CNL-15-067

Subject: **Completion of Required Action by NRC Order EA-12-051, Reliable Spent Fuel Pool Instrumentation**

**RESPONSE TO THE NRC REQUEST FOR ADDITIONAL INFORMATION REGARDING  
OVERALL INTEGRATED PLAN FOR RELIABLE SPENT FUEL POOL INSTRUMENTATION**

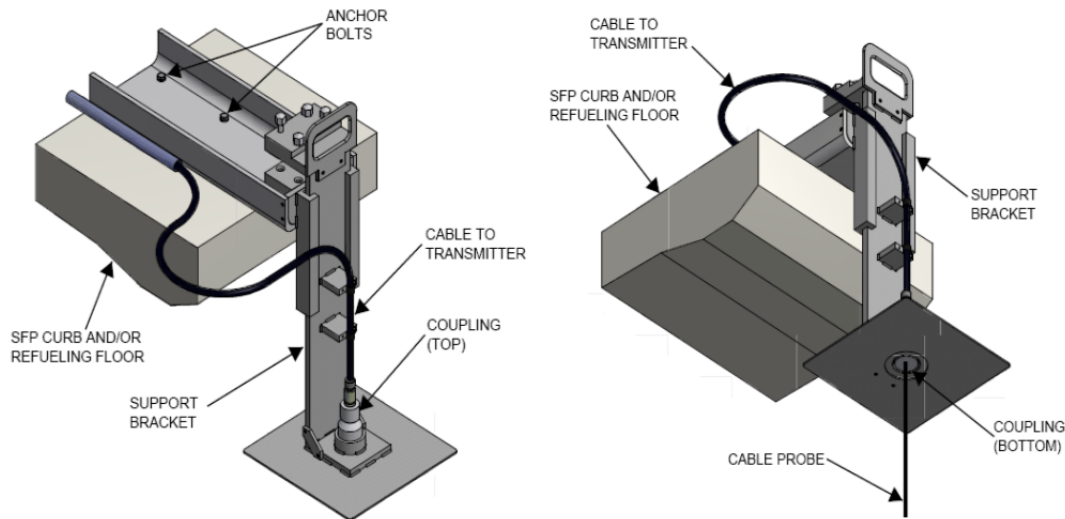
- a) The design criteria used to estimate the total loading on the mounting device(s), including static weight loads and dynamic loads. Describe the methodology that will be used to estimate the total loading, inclusive of design basis maximum seismic loads and the hydrodynamic loads that could result from pool sloshing or other effects that could accompany such seismic forces.*
- b) A description of the manner in which the level sensor will be attached to the refueling floor and/or other support structures for each planned point of attachment of the probe assembly. Indicate in a schematic the portions of the level sensor that will serve as points of attachment for mechanical/mounting or electrical connections.*
- c) A description of the manner by which the mechanical connections will attach the level instrument to permanent SFP structures to support the level sensor assembly.*

The seismic loads are obtained from response spectra curves and damping values for the application. The following methodology was used in determining the stresses developed for the model.

- Frequency analysis is performed to obtain the natural frequencies of the structure in all three directions.
- SSE response spectra analysis is performed to obtain member stresses and support reactions due to the self weight of the bracket and associated components in a seismic event.
- Response spectra analysis results in each direction are combined using square root of the sum of the squares (SRSS) method. The seismic results in all three directions are combined using SRSS and then combined with the dead load results in absolute values. The combined results are compared with the allowable stress values.

SQN Plan View of SFP Area - Response to RAI #1

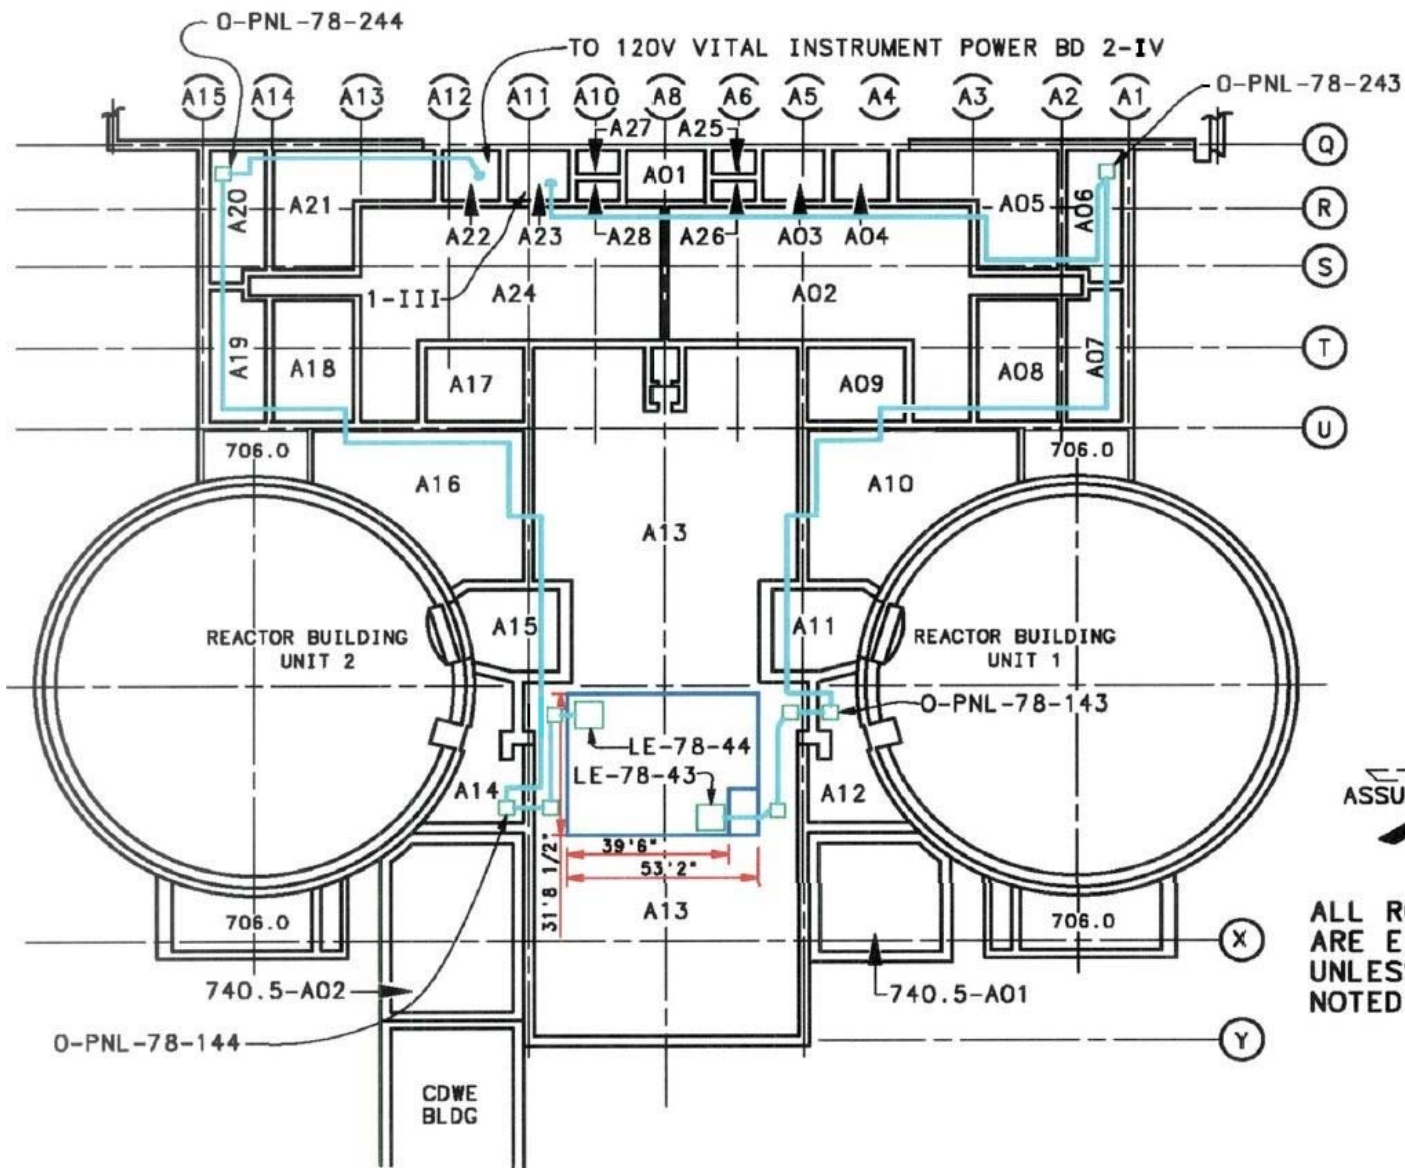
*Please provide a clearly labeled sketch or marked-up plant drawing of the plan view of the SFP area, depicting the SFP inside dimensions, the planned locations/placement of the primary and back-up SFP level sensor and mounting brackets, and the proposed routing of the cables that will extend from the sensors toward the location of the read-out/display devices.*

See Attachment 2 for plan view of the spent fuel pool (SFP) area, depicting the requested information.
